# SERVICE <sup>No. 191</sup> BULLETIN

**SUBJECT:** Aileron Hinge Bracket - Part No. 20211-00

**MODELS AFFECTED:** PA-24 and PA-24-250 Comanches  
Serial Nos. 24-1 to 24-1243 inclusive

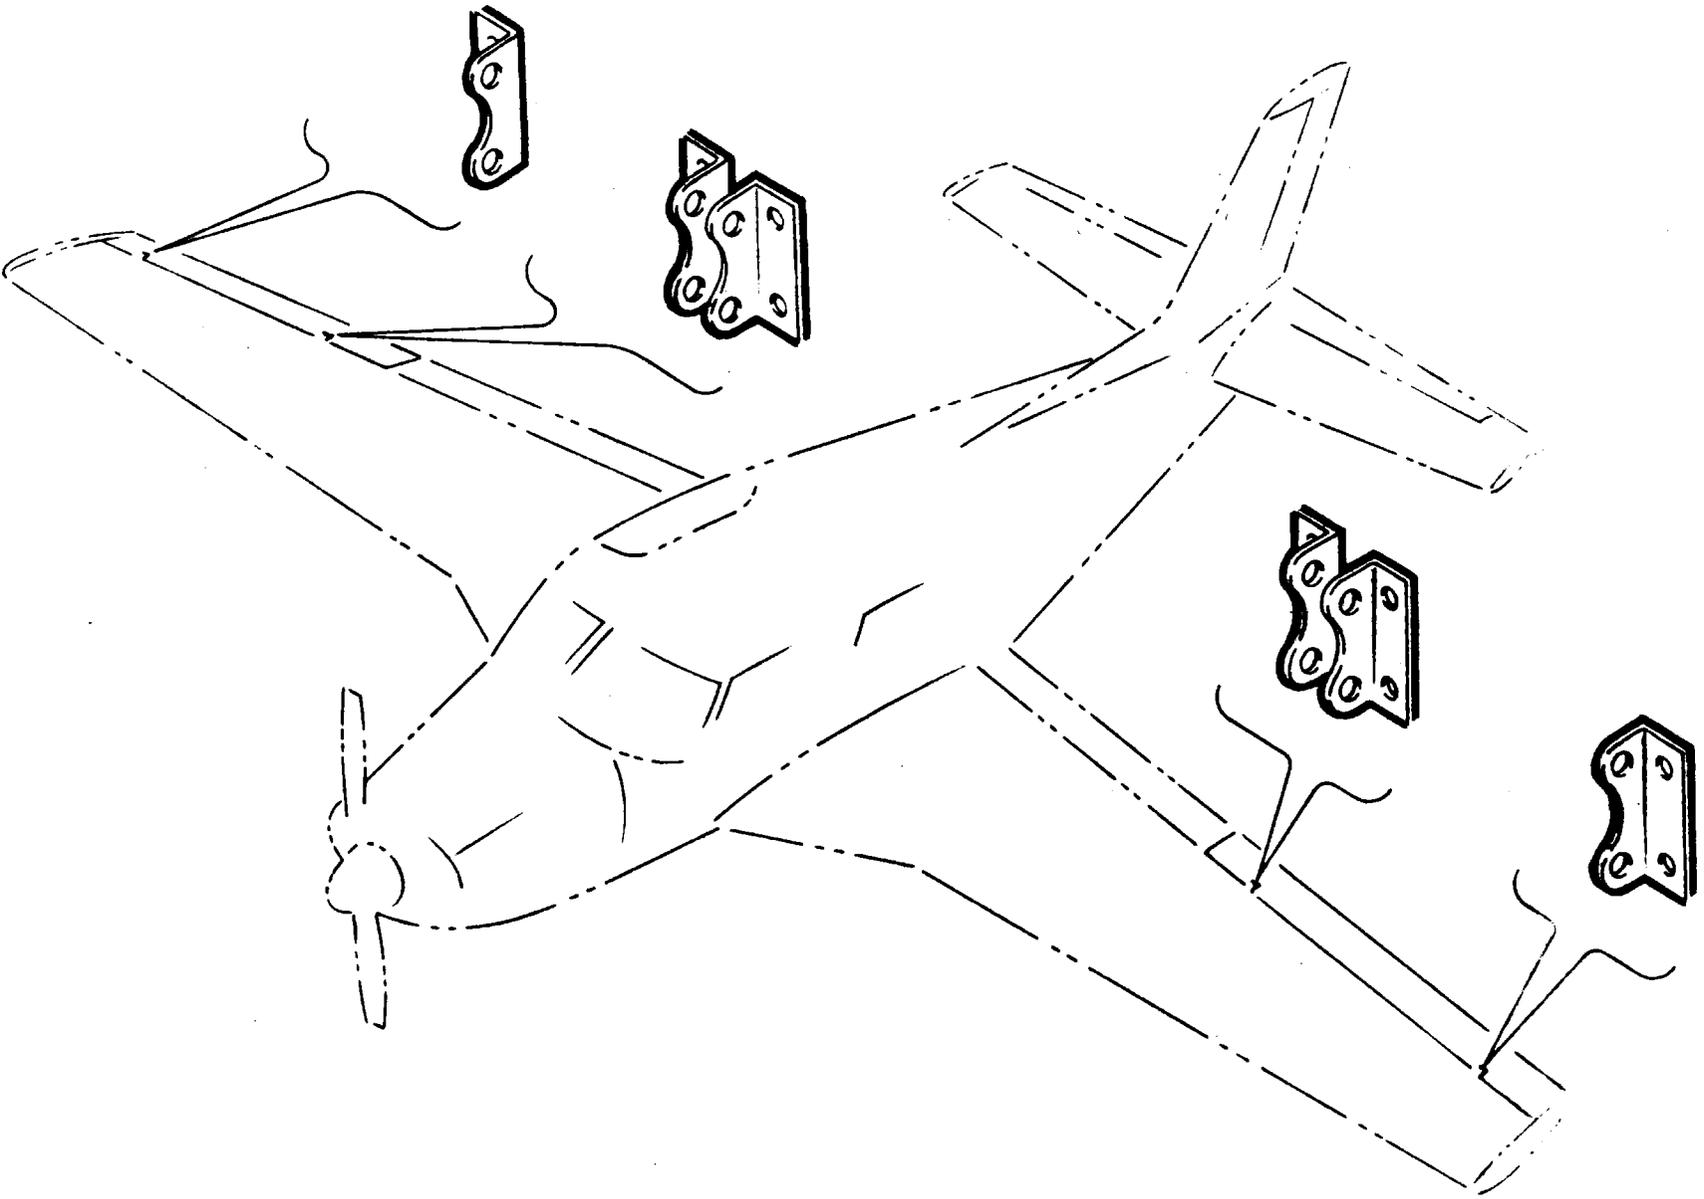
It has been brought to our attention in a recent report from the field that a crack was discovered in one of the subject aileron hinge brackets, part number 20211-00.

This report is an isolated case, however, we feel that a visual inspection of these brackets should be made on all Comanches as indicated by the above serial numbers and any cracked brackets should be replaced.

Reference to the sketch on the reverse side of this bulletin will indicate the location of these brackets.
